RE: HOLD HARMLESS AGREEMENT, LOT 1433, SANDIA HEIGHTS SOUTH

Case No.: BP-92-755

RE: DRAINAGE PLAN FOR LOT 1433, SANDIA HEIGHTS SOUTH, UNIT 14,
(D-23/D25), ENGINEER'S STAMP DATED NOVEMBER 5, 1992, (BP92-755)

TOMKINS RESIDENCE GRADING AND DRAINAGE PLAN			
KEMPER-VAUGHAN CONSULTING ENGINEERS			
3700 COORS RD. N.W. • ALBUQUERQUE, NEW MEXICO 87120 • (505) 831-4520			
Designed KRK	Drawn SE	Checked KRK	Sheet 1 of 1
File TOMKINS	Date SEPTEMBER 1992

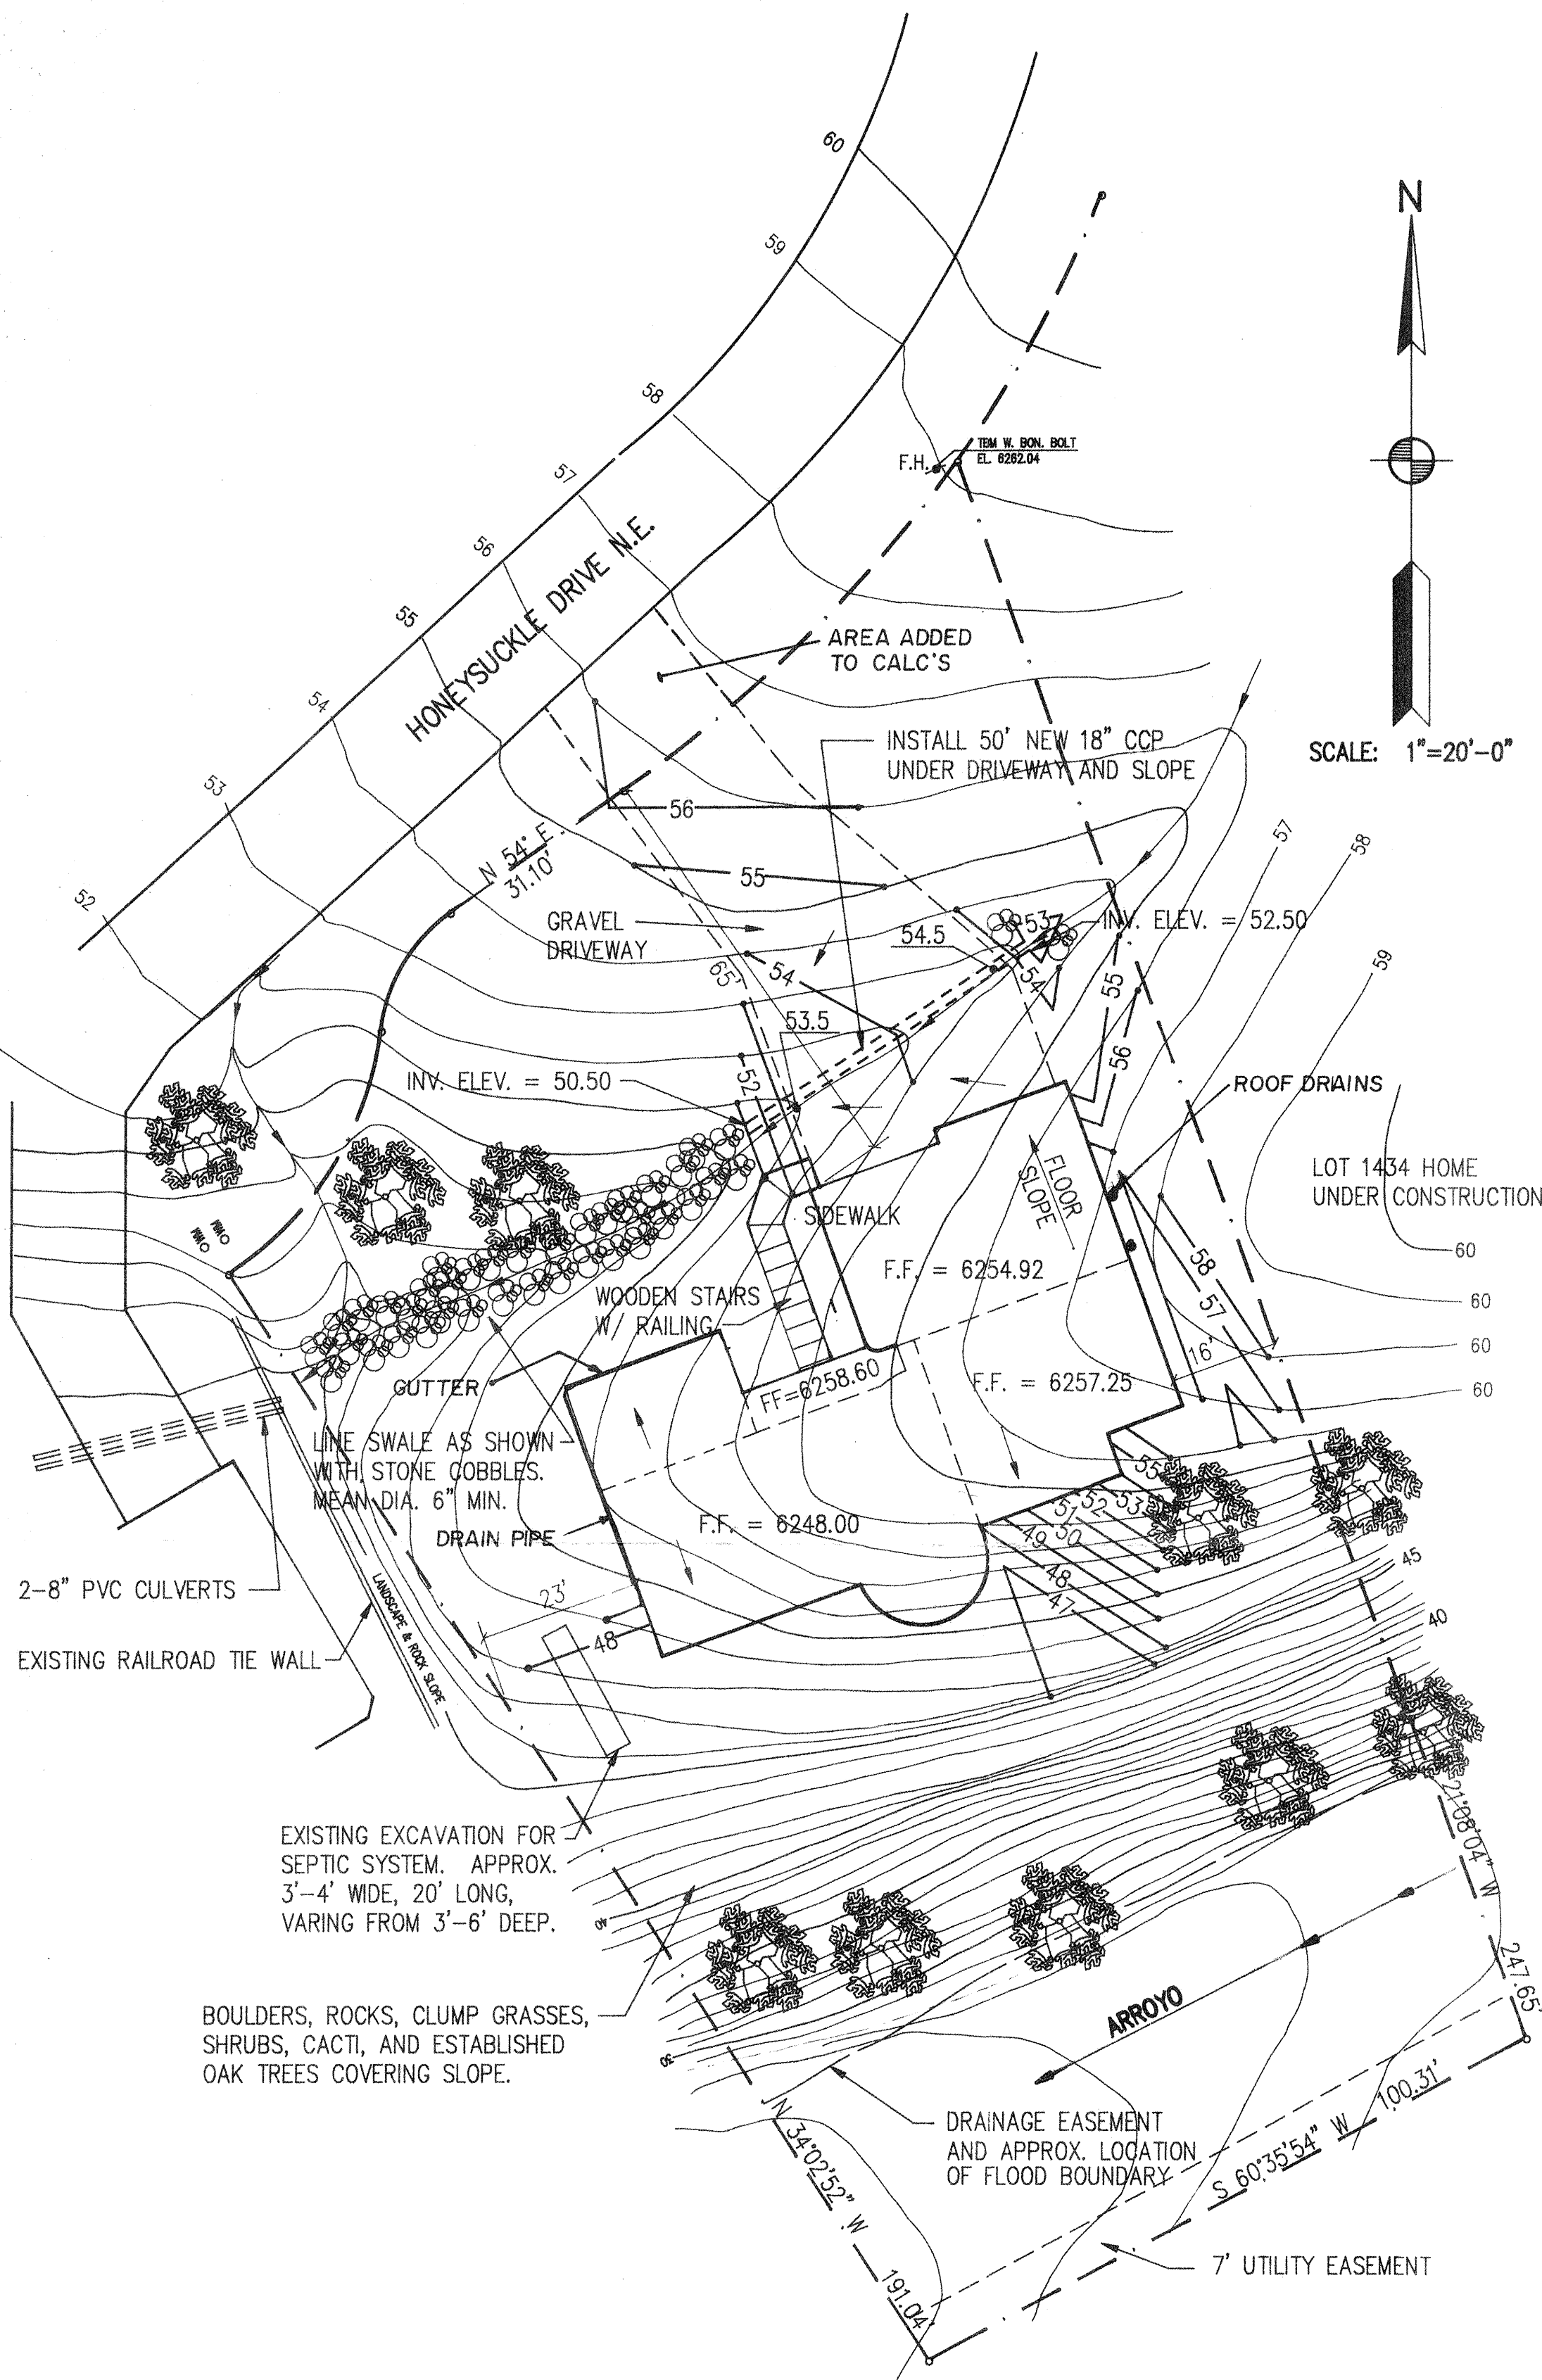
14-JAN-93 DRAN: 1. Based on the information provided on the Grading & Drainage Plan, with engineers seal last dated 11/5/92, the plan appears to meet the requirements established for this area and is therefore acceptable.

2. As shown on this plan, offsite areas drain through this property and will continue to drain through this property after development. Also, as shown on this plan, no external or property line walls or fences, which includes chain link fencing, will be constructed which may impede offsite drainage areas from continuing to drain through this property.

3. Development of this property must conform to this plan. Any proposed changes will require a revision to the plan prior to initiating the proposed change.

4. Prior to the County Building Department performing a final inspection, certification to the Floodplain Administrator that the site is in substantial compliance with this plan will be required.

Based on the information provided on the referenced plan received November 6, 1992, the plan is acceptable for Building Permit release with the condition that the County is released from liability arising from possible flooding onto lot 1434 because of limited capacity and due to development of this site (per Hold Harmless Agreement dated September 25, 1992).

The House Plans need to show the gutter as required per this plan.
